E/ECE/324
E/ECE/TRANS/505 } Add.6/Rev.2/Amend.1
4 March 1994

Addendum 6 – Regulation No. 7

Revision 2 – Amendment 1

UNIFORM PROVISIONS CONCERNING THE APPROVAL OF FRONT AND REAR POSITION (SIDE) LAMPS, STOP-LAMPS AND END-OUTLINE MARKER LAMPS FOR MOTOR VEHICLES (EXCEPT MOTOR CYCLES) AND THEIR TRAILERS

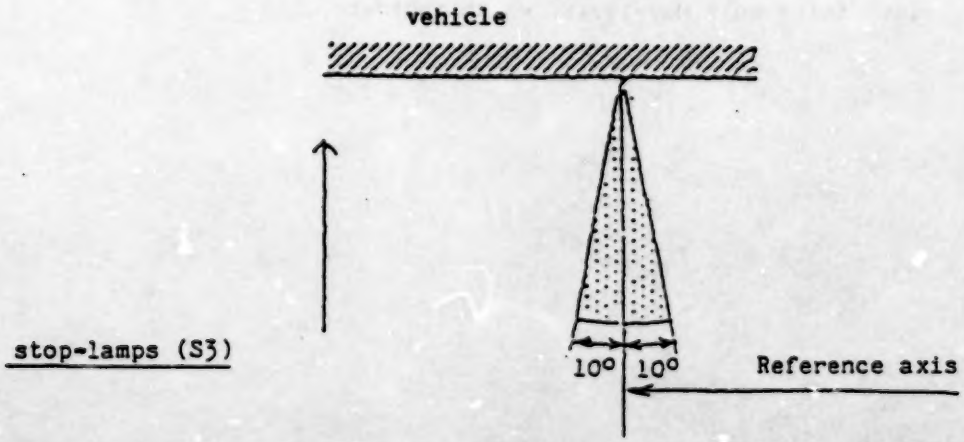
In the figure "Minimum horizontal angles of light distribution in space," amend the title of the third diagram "Stop lamps" to read "Stop lamps (S1 and S2)" and add a new fourth diagram to read:
